SIAE Microelettronica SpA:

Answers to Ofcom Consultation on the future management approach for the 70 / 80 GHz bands

Figure 1: SIAE Proposal (see answer to Questions 2b, 3a and 4b)

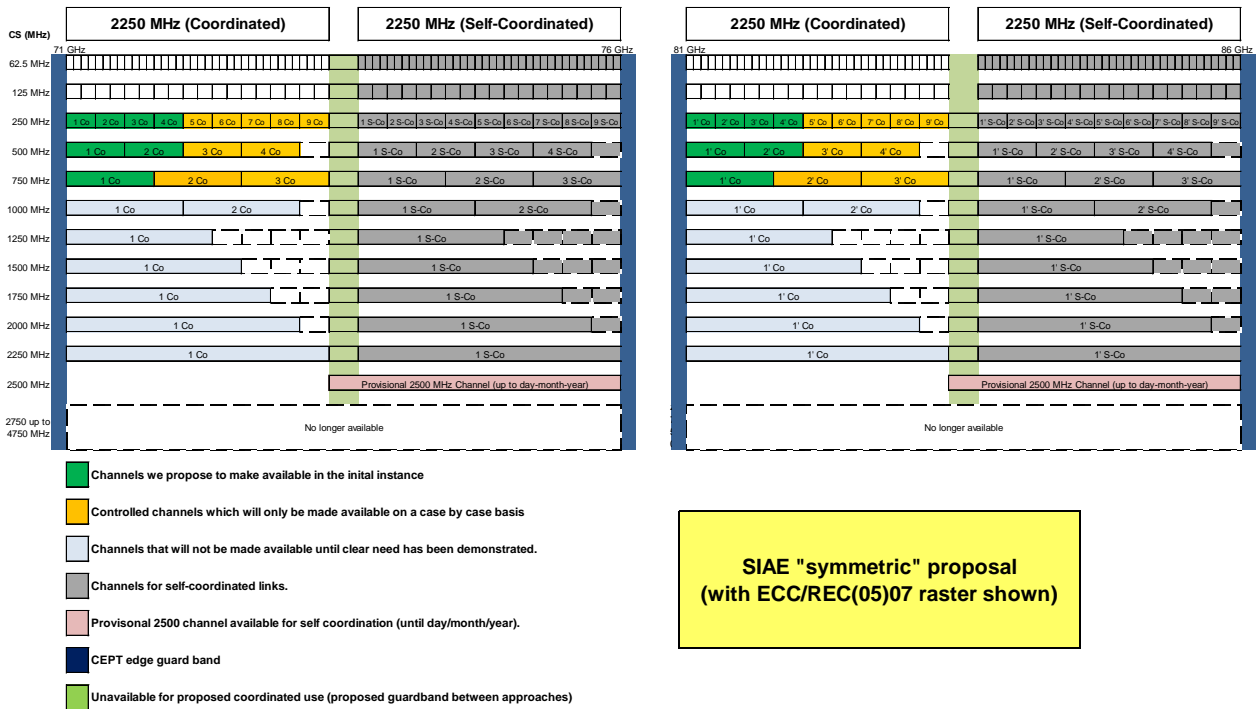
b) We do not agree: “asymmetric size” segmentation is not appropriate; the best solution would be to have two equally built segment of 2 x 2.25 GHz (i.e. exactly in the middle of the 71-76 GHz and 81-86 GHz sub-bands).

Rationale for that is that very soon, when the backhauling market will be fully in place, the equipment for the self-coordination market will become exactly the same. Therefore, considering that, in principle, the difference between self-coordination and coordination is only of administrative nature, there should be no difference in the size of the two segments, in particular if the CEPT channel plan is adopted, which also provides symmetric arrangements in the two segments.

The small proposed shift of the segmentation, rendering it “symmetrical”, would have the following impact on the two segments:

– In symmetrical segmentation CEPT channel plan perfectly fits in both segment.

– Also the coordinated segment will have 3 full channels of 750 MHz size. This channel size is that immediately above the present assumption of 250/500 MHz and would be the next natural choice for equipment designers of multi-gigabit links with higher NQAM systems (efficient equipment, i.e. ETSI Class 2, for 1 Gbit/s within 750 MHz, are already available on the market). Having 3 channels available instead of 2 would greatly enhance the planning options in congested nodes.

In Figure 1 (see end of the document) we graphically show the perfect balancing of this solution.

Therefore, having symmetric 2 x 2250 MHz available in both segments might be best solution. Existing systems should not be impacted, but a “permanent grandfathering” of one of them, only in the self coordinated segment, seems not paying-back the reduced possibility of 750 MHz and other channels availability in the coordinated segment.

A more consistent grandfathering can be more profitably obtained through temporary (e.g. few years) permission of further registration of 2500 MHz systems (i.e. using also the guard band) in the self coordinated segment. See graphical view in Figure 1; it should also be considered that, with the increasing link density also in the self-coordinated segment, such systems will experience more and more difficulty in finding co-channel interference free conditions.

a) We agree, but we suggest considering also the opportunity of the 750 MHz channel(s) option, e.g. 1 channel immediately available and the other(s) when needed (see Figure 1 at the end of the document).

b) Yes. Rationale is that if a channel plan is beneficial for high density deployment of coordinated networks, there is no reason why this would not happen also in self-coordinated networks (technical aspect is the same). In addition, as discussed above equipment addressing the self coordinated market could, in short time, not be distinguishable from those for coordinated applications (see graphical solution in Figure 1 at the end of the document).
